**RE: Lincoln Drive Median Access from Mockingbird Lane to the Eastern Town Limits**

## MEMORANDUM

Subject: Lincoln Drive, Mockingbird Lane to Town of Paradise Valley (TOPV) Jurisdiction  
Median Breaks and Access  
Third Party Traffic Review Comments

## Resort Hotel (330)

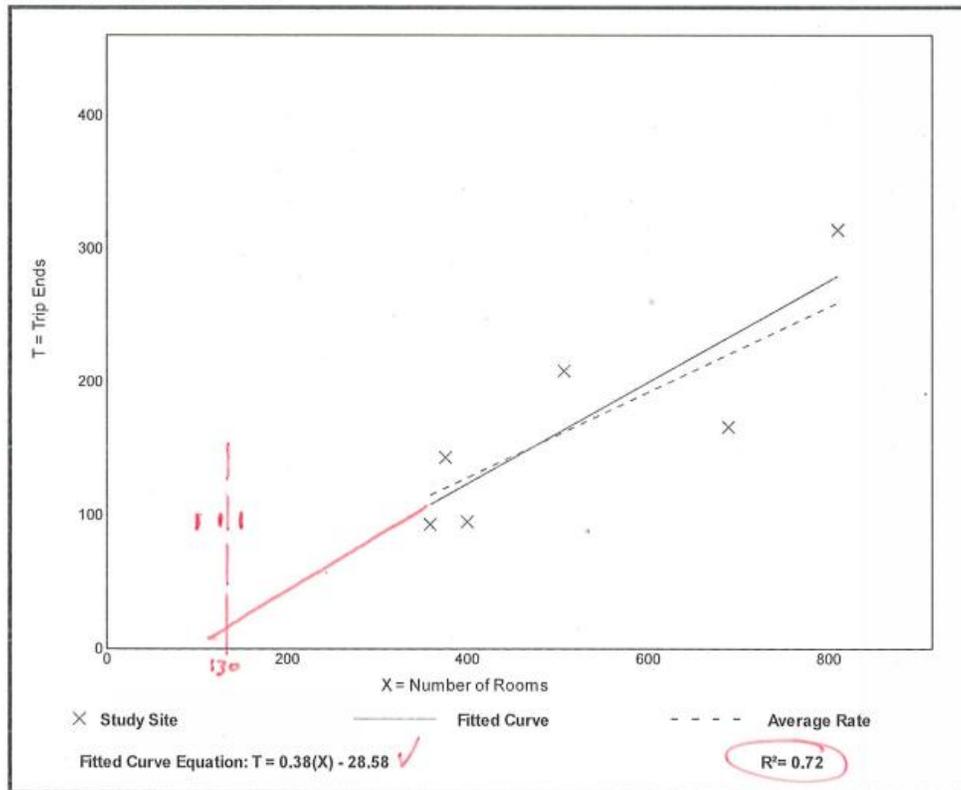
**KH Comments 4:** Smoke Tree Resort utilized equations as opposed to average rates. KHA went through the ITE Trip Generation Handbook process presented in Figure 4.2 assuming proposed number of units for resort hotel (LUC 330). The results of this process are presented below and KH redlines provided in **Appendix 1**.

- The number of rooms is way out of range of the data extremes; the lowest number of rooms in the manual is roughly 370 compared to the 132 that are proposed
- If you follow the equation, which happens to be a straight line and not a logarithmic function, then 132 rooms will generate a very low number of trips
- The number of data points is equal to 6
- The R2 value is close to the required 0.75, so you could argue it either way
- The standard deviation is less than 55% of the average rate

Because the rooms are not within the data extremes and the R2 value is less than 0.75, we recommend the weighted rates be used. Using the rates as opposed to the equation results in double the trips being generated in the AM peak hour.

**Response to Comment 4:** CivTech has updated the trip generation rates to reflect a blended rate between LUC 310 and 330 as discussed in response to comment #3. The trip generation calculations were also revised to reflect 150 rooms, 30 residential units, and 3500 square foot quality restaurant. The revised trip generation calculations and approach were considered acceptable. The revised trip generation calculations, based on 150 rooms, 30 residential units, and 3500 square foot quality restaurant, are provided in **Appendix 2**.

## Resort Hotel (330)

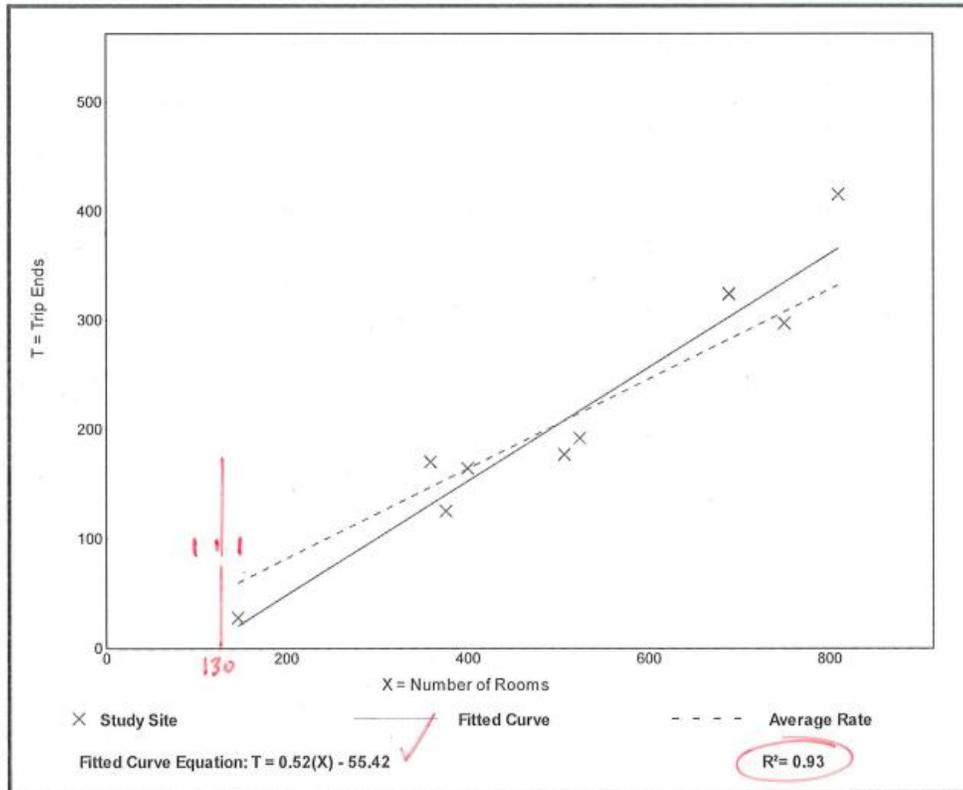
- The number of rooms is just outside of the data extremes
- The number of data points is greater than 6
- The R2 value is well above the required 0.75
- The standard deviation is less than 55% of the average rate

Because the number of data points and the R2 value are high enough and the standard deviation requirement is met, the use of the equation during the PM peak is appropriate.

01 OF 03

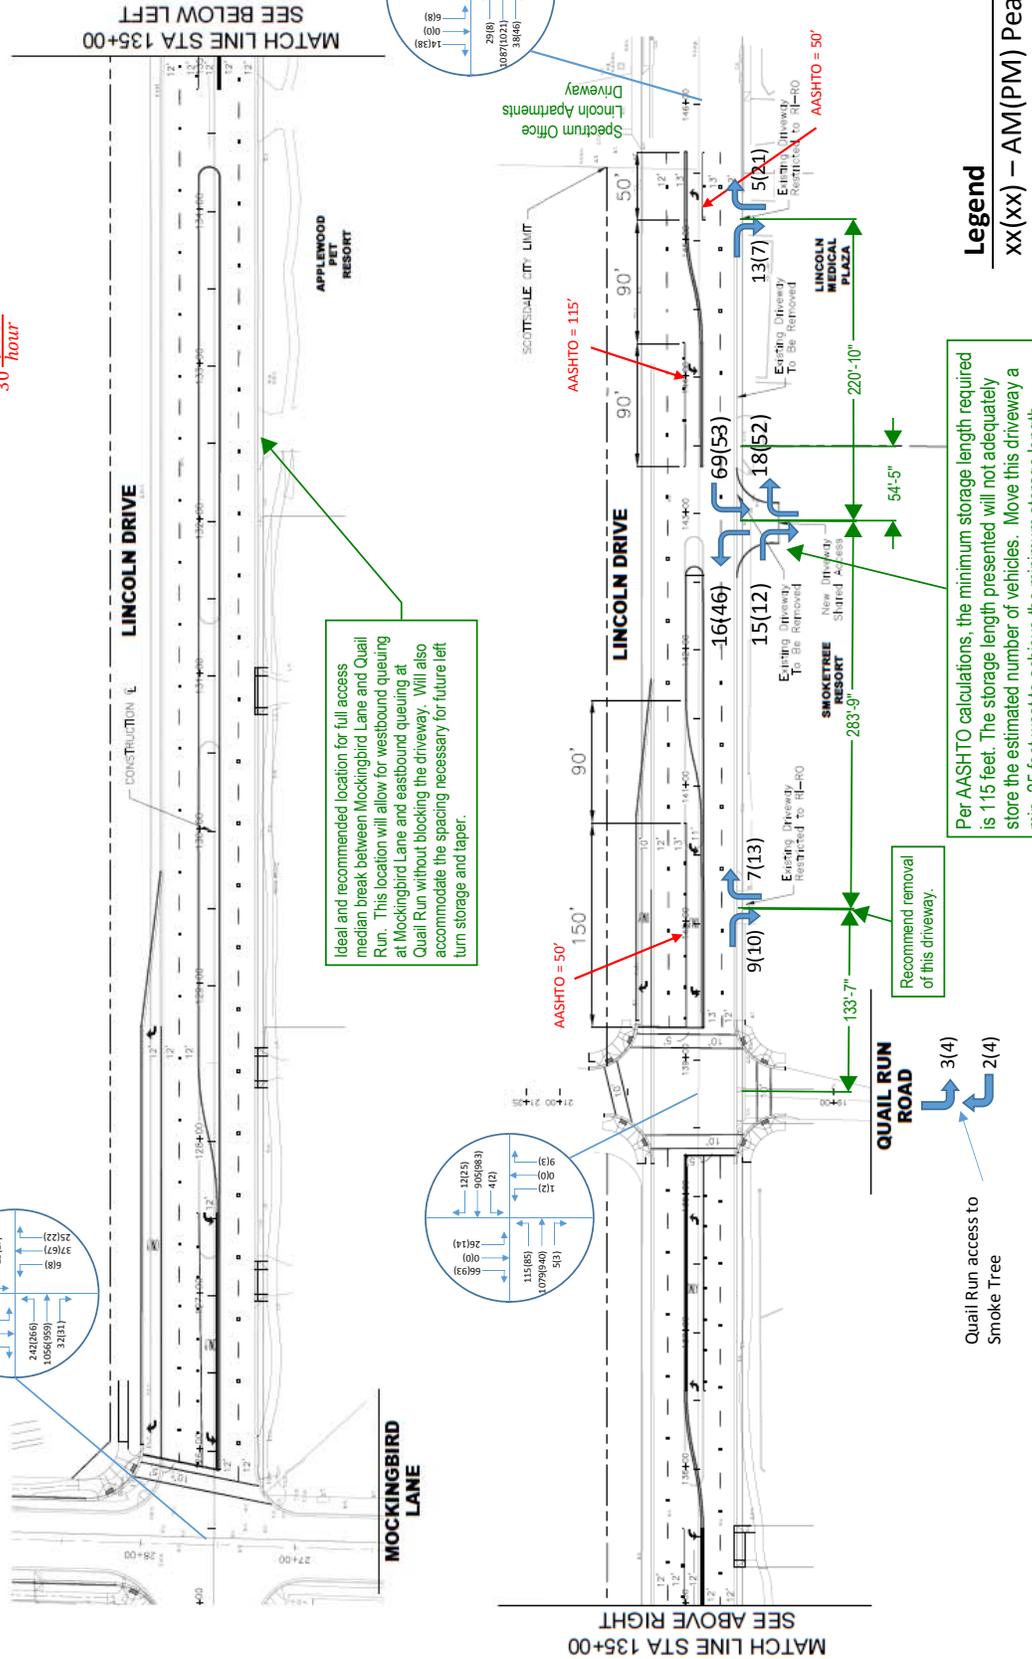
**KH Comment 10:** Storage length at Spectrum Office Driveway/AJ Driveway calculation ((29 vph x 25 feet x 2)/30) is 48 feet. Per AASHTO, the minimum storage length is 50 feet. Exhibit illustrates a minimum of 50 foot being provided. This is considered acceptable.

**KH Comment 11:** As shown in Option #1 exhibit, access improvements include closure of the existing eastern access on Smoke Tree Resort, a new Smoke Tree Resort access approximately 183 feet west of Lincoln Medical Plaza access, and the existing Smoke Tree Resort western access to remain as right in/right out. The proposed improvements result in the following spacing (centerline to centerline) of driveways:

Based on the results, Kimley-Horn recommends the western Smoke Tree Resort driveway be closed to achieve the minimum spacing from Quail Run.

**KH Comment 12:** The storage length shown in Option #1 exhibit for Lincoln Medical Plaza is 70 feet. Per AASHTO calculations, storage length should be no less than 70 feet to adequately store the estimated number of vehicles generated by Lincoln Medical Plaza. This is considered acceptable. The storage length for the Smoke Tree Resort eastern driveway is 75 feet. Per AASHTO calculations, storage length should be no less than 55 feet to adequately store the estimated number of vehicles generated by the Smoke Tree Resort. This is considered acceptable.

**KH Comment 13:** As shown in Option 1 exhibit prepared by CivTech, opening bay tapers are 40 feet at Smoke Tree Resort and 43-3” feet at Lincoln Medical Plaza. KH recommends that no less than a 90-foot opening taper be utilized to safely traverse traffic from the through lane to the left turn lane on Lincoln Drive, per the criteria and discussion on Page 4, 5, and 6 of this document. Kimley-Horn recommends the median be extended and access points to Lincoln Medical Plaza be restricted to right in/right out only movements for two reasons:

**Option 2 Shared Access**

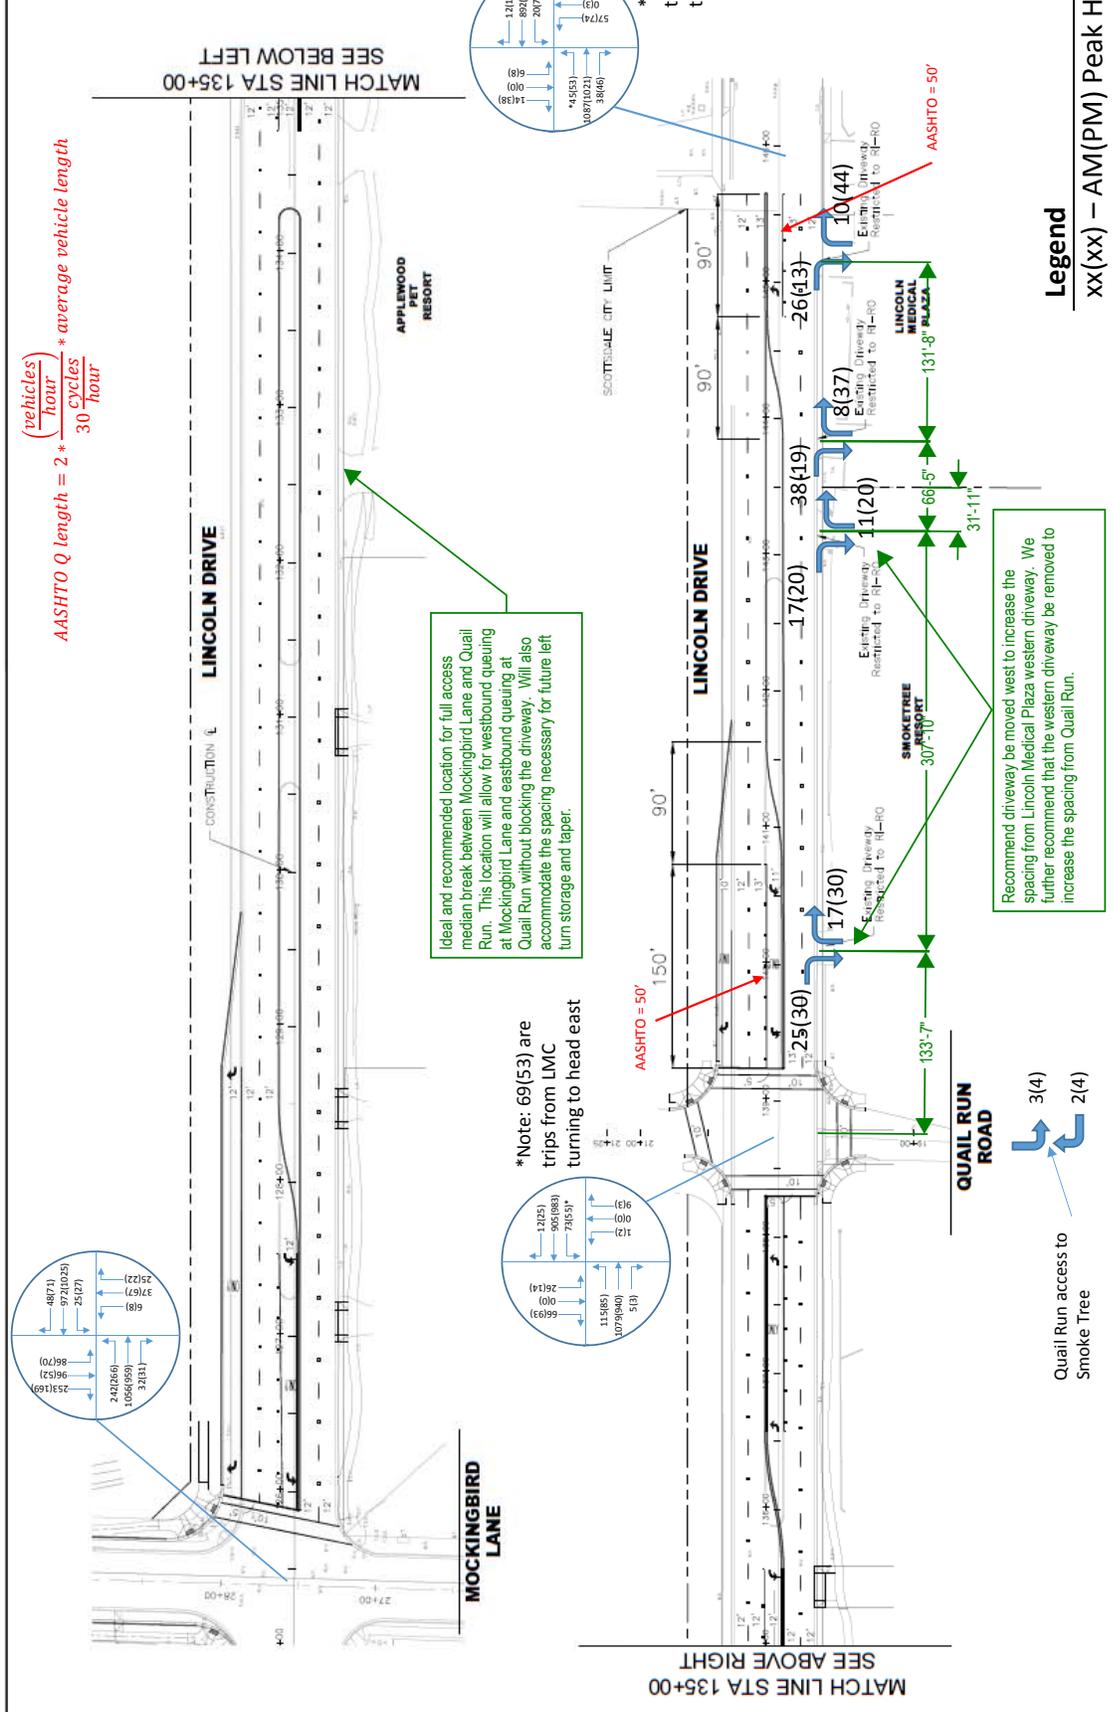
**KH Comment 14:** As shown in Option #2 exhibit, access improvements include closure of the western Lincoln Medical Plaza access, a new shared access for the Smoke Tree Resort / Lincoln Medical Plaza approximately 55 feet from the shared Smoke Tree Resort / Lincoln Medical Plaza parcel line, and right in/right out to all other access points between Quail Run and TOPV jurisdictional boundary line. The proposed improvements in this option result in the following spacing (centerline to centerline) of driveways:

**KH Comment 15:** As shown in Option 2 exhibit prepared by CivTech, opening bay taper to the shared Smoke Tree Resort and Lincoln Medical Plaza is 90 feet. This is considered adequate.

**KH Comment 16:** The storage length shown in Option #2 exhibit for the shared Smoke Tree Resort/Lincoln Medical Plaza access is proposed at 90 feet. Per AASHTO calculations, storage length should be no less than 115 feet to adequately store the estimated number of vehicles generated by

*Smoke Tree Resort and Lincoln Medical Plaza. For this option, the shared access should move a minimum of 25 feet west of the location shown in the CivTech exhibit to accommodate the minimum storage length necessary to adequately store the estimated left turn volumes without spilling back into Lincoln Drive through lanes. This would result in placing the shared driveway a minimum of 80 feet from the Smoke Tree resort/Lincoln Medical Plaza parcel line.*
